4 ELLERDALE CLOSE, NW6

DRAWING NAME:
PROPOSED ROOF PLAN

PROJECT NO: P1011 DRAWING NO: PL604 REVISION: A SCALE @ SIZE: 1:100 @ A3

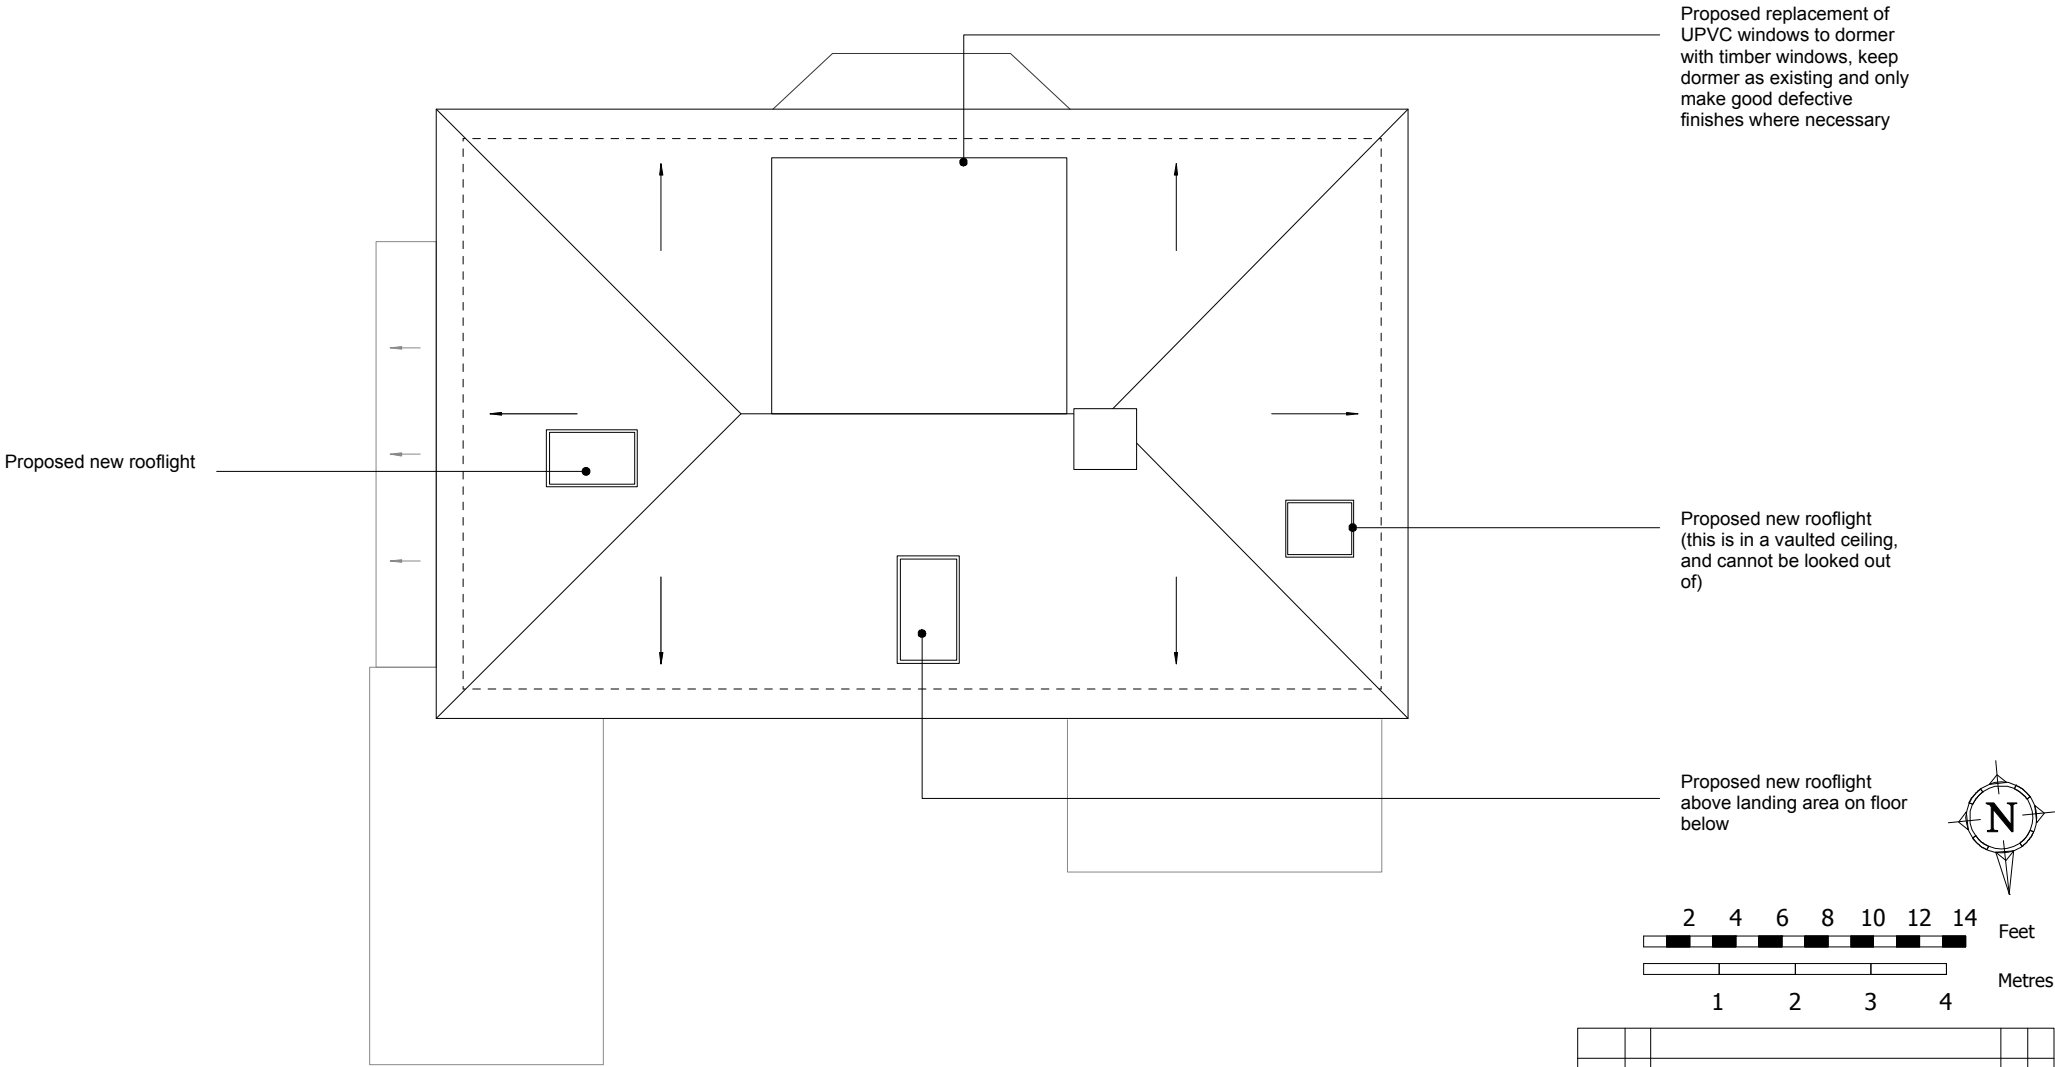
20.04.22	A	Removal of one rooflight from front elevation as requested by planning officer.	MS	GT	
16.12.21	-	First issue	MS	GT	
DATE:	REVISION:	REVISION COMMENTS:	AUTHOR:	CHECKED:
